SUBJECT: EPRI INTERIM REPORT "RESOLUTION OF GENERIC LETTER 96-06 WATERHAMMER ISSUES - NRC STAFF FOLLOW UP"

SUBJECT: ACRS COMMENTS ON EPRI INTERIM REPORT TR-113594,
"RESOLUTION OF GENERIC LETTER 96-06 WATERHAMMER
ISSUES"

SUBJECT: EPRI INTERIM REPORT TR-113594, "RESOLUTION OF GENERIC LETTER
96-06 WATERHAMMER ISSUES"

Comments on EPRI Interim Report, TR-113594
"Resolution of Generic Letter 96-06 Waterhammer
Issues"

**Figure 1. Flow diagram and topics addressed in TBR
(items in dotted boxes are not detailed in TBR)**

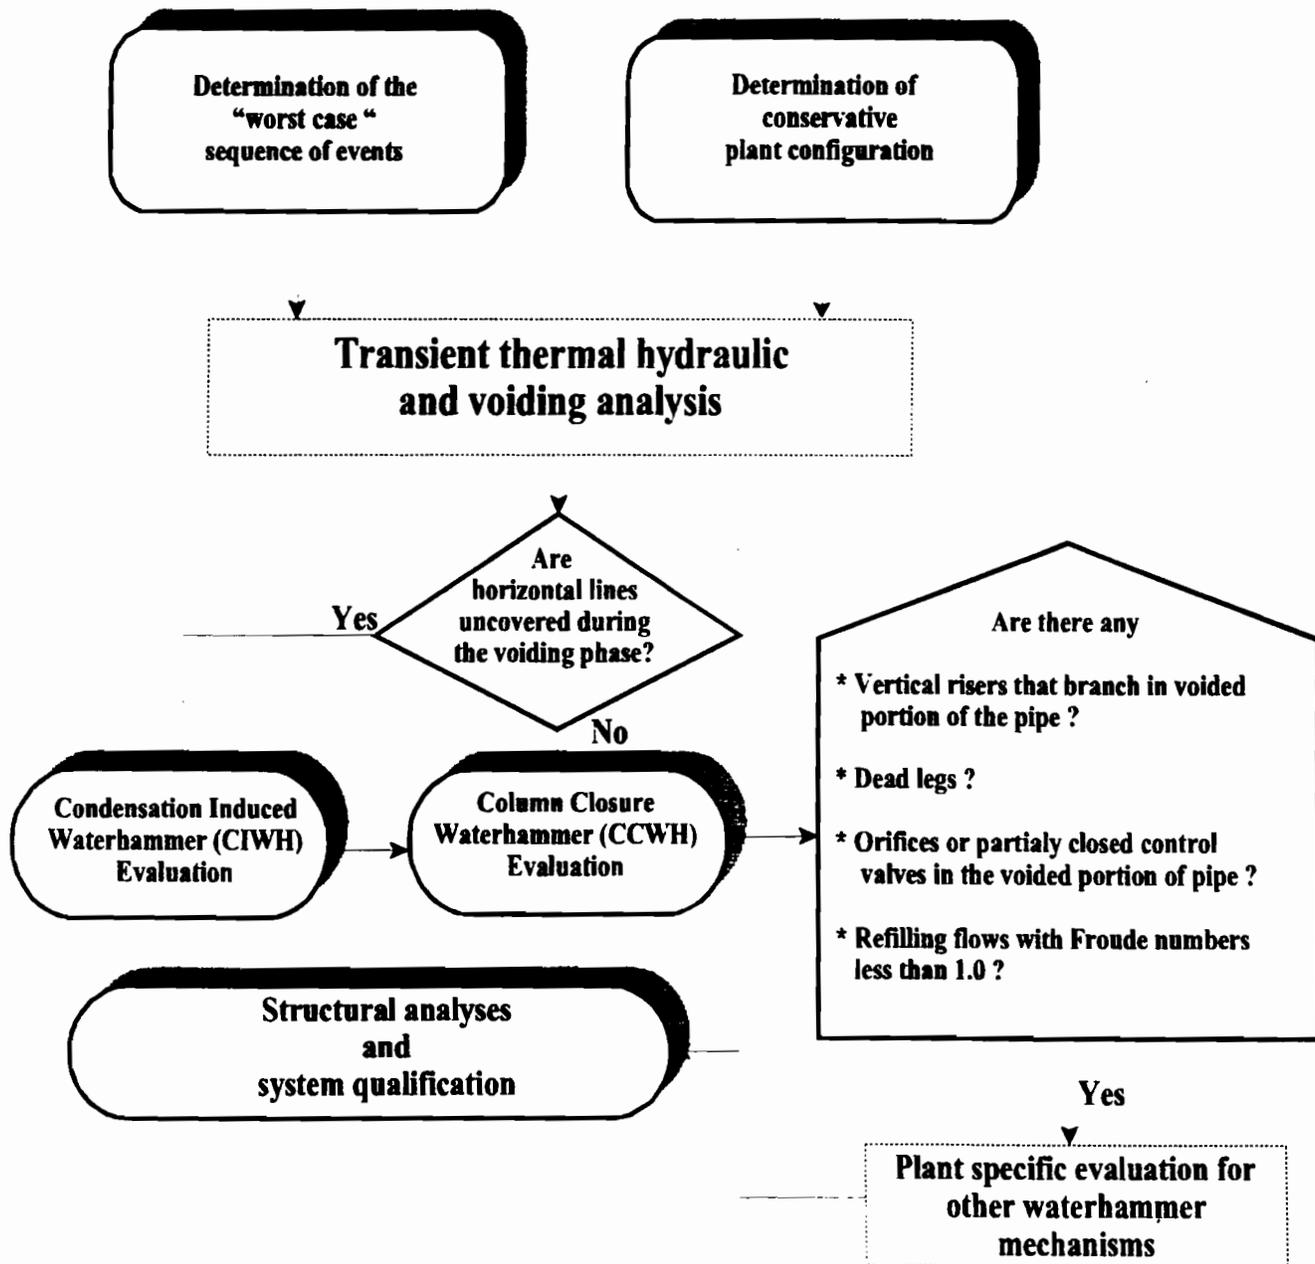
However, the "road map" for an approach to the overall issue, described in Section 1.5 of the interim TBR (see also Figure 1), uses the uncovering of the horizontal lines during the voiding phase as the only criterion for the assessment of the condensation induced waterhammer. Further clarifications on validation and endorsement of the above criteria (suggested in NUREG/CR-6519) by EPRI/Industry approach are needed.

The interim TBR also recognizes the potential for occurrence of other waterhammer mechanisms and they have been expected to be insignificant for most cases (Section 6 of TBR). The interim TBR provides a checklist (see Figure 1) that should be utilized to assure that specific plant conditions are not conducive to such waterhammer events. If any of these checklist items are present, a plant-specific evaluation is required. However, the interim TBR provides no specific guidance for such plant-specific evaluations.

- No specific guidance for system thermal hydraulic and voiding analysis was provided.
- Further clarifications on validation and endorsement of the criteria (suggested in NUREG/CR-6519) for the assessment of the condensation induced waterhammer are needed.
- No specific guidance for plant-specific evaluations of other waterhammer mechanisms was provided.

Figure 2. Flow diagram for CIWH evaluation (items in the dotted box is not detailed in TBR)

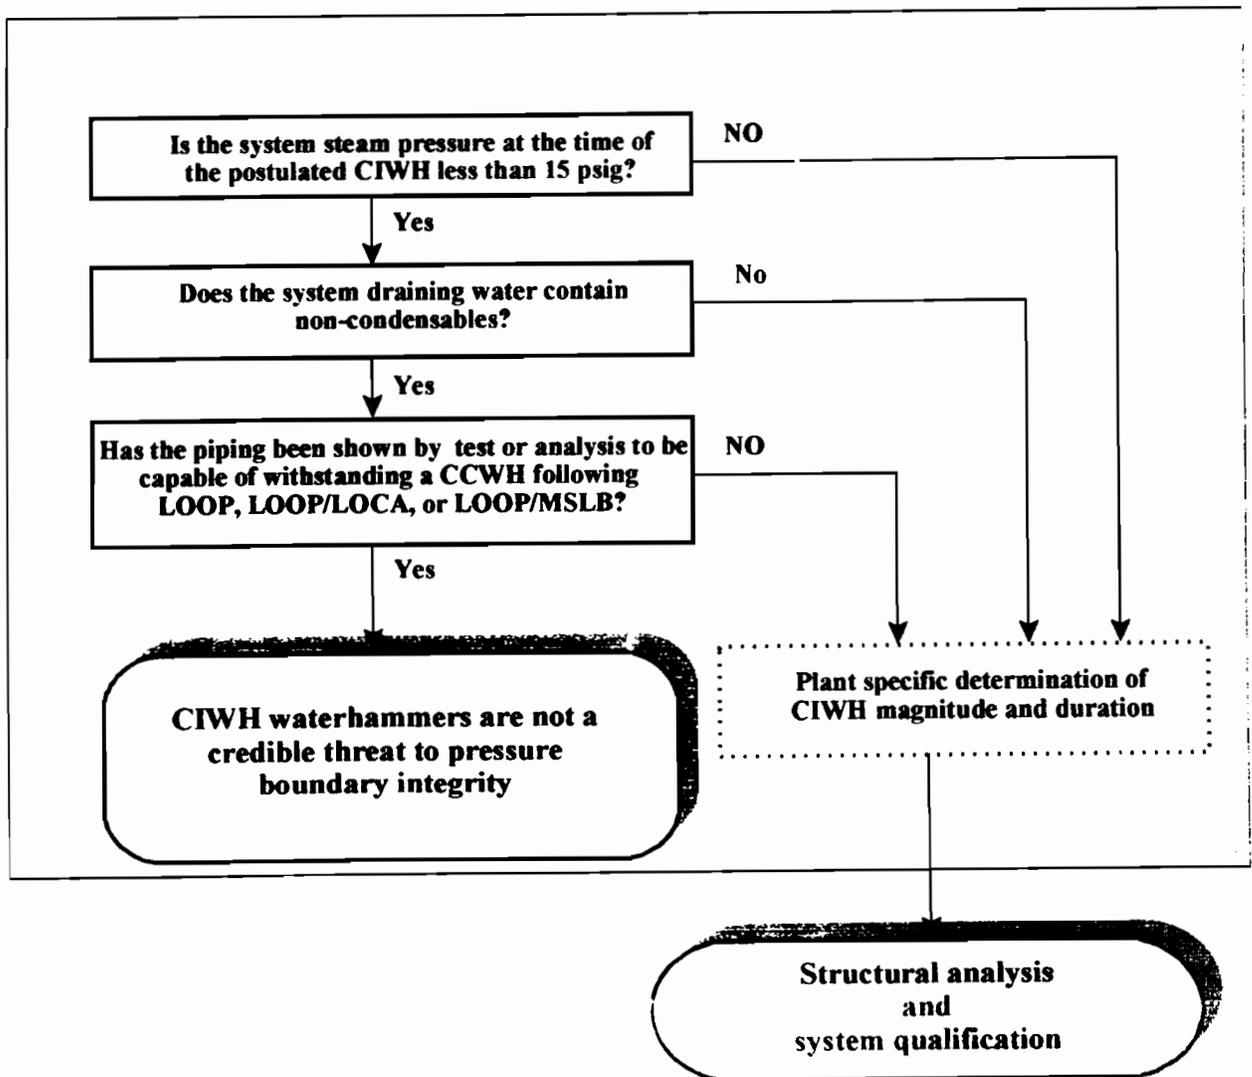
The interim TBR (page 8-24) also concluded that the waterhammer pressures are independent of pipe size (Froude number) for the range of concern here (2" to 16"). This conclusion was made primarily by comparison of 2" and 4" CIWH tests results. The interim TBR also used a simple scaling rationale, based on an equation for steam velocity obtained from a heat balance on the water/steam interface, for further explanation of size (diameter) independence. It was demonstrated that the steam velocity is primarily dependent on the slope of water/steam interface. However a proper justification was not provided for the statement, "as the pipe size changes no significant

- A proper justification for the conclusion that the CIWH pressures are independent of pipe diameter (Froude number) for the range of concern (2" to 12") is needed.
- A more explicit quantitative requirement on the concentration of non-condensables in the water, so that CIWH will not have to be explicitly calculated, is needed.
- Without quantifying the uncertainties associated with the void air concentration, use of the Configuration #2a data for model validation is questionable.
- Without quantifying the biases due to scale distortion or due to non-prototypical conditions of the small scale testing, the conclusion of this testing (that water with dissolved gas will release at least 40% of its gas) is questionable and may not be conservative for plant applications.

Figure 3. Flow diagram for CCWH evaluation (items in dotted boxes are not detailed in TBR)

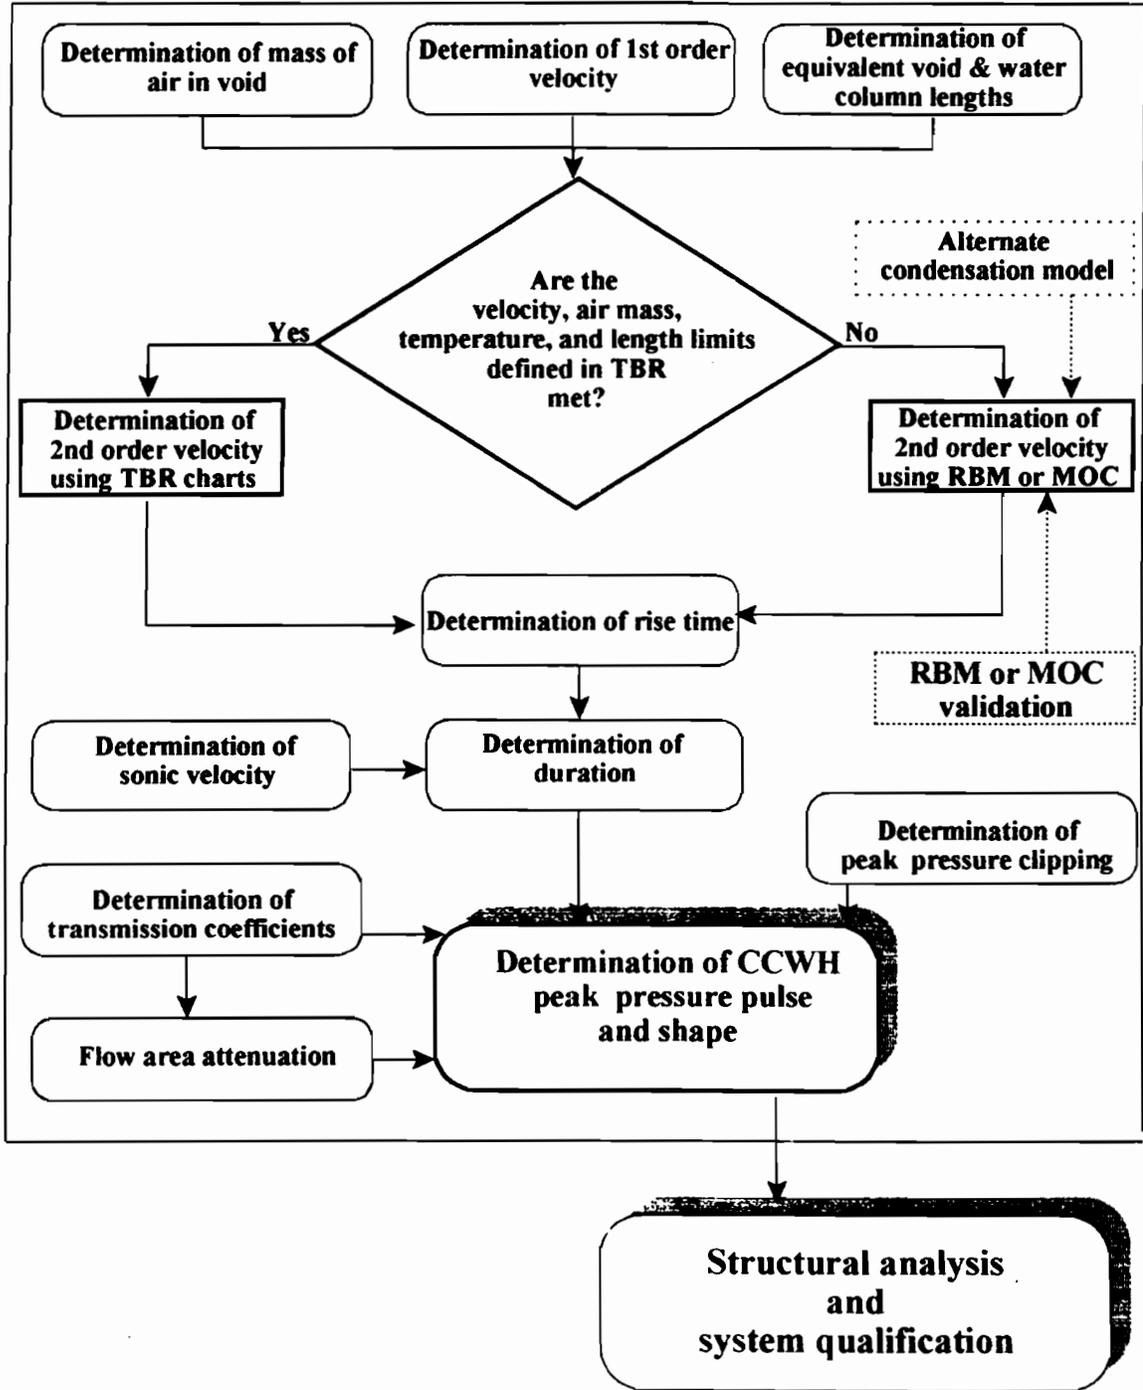
The major components of the suggested utility approach for evaluating the column closure waterhammer are shown in Figure 3 (see also Appendix H of the interim TBR). This evaluation requires many important input parameters (such as void length and location, void temperature, and flow distributions in the system) which are obtained from thermal hydraulic analysis of the voiding phase. However , as discussed earlier in Section 2, the Interim TBR does not provide any guidance for such system thermal hydraulic and voiding analysis to quantify these parameters. It should be noted that the element of “ determination of equivalent void & water column lengths”, shown in Figure 3, only refers to calculation of equivalent lengths (based on the actual void and water column locations) required for the simplified representation of the system for the proposed evaluation methodology and does not refer to a thermal hydraulic and voiding analysis.

- In the presence of external heat transfer from the containment atmosphere to the piping, the validity of the alternate method of calculating the mass of non-condensable gas released is questionable and may not be conservative.
- No guidance was provided on how an alternate condensation model should be obtained, and how to validate the RBM or MOC models, if the velocity, air, or temperature limits are not met.
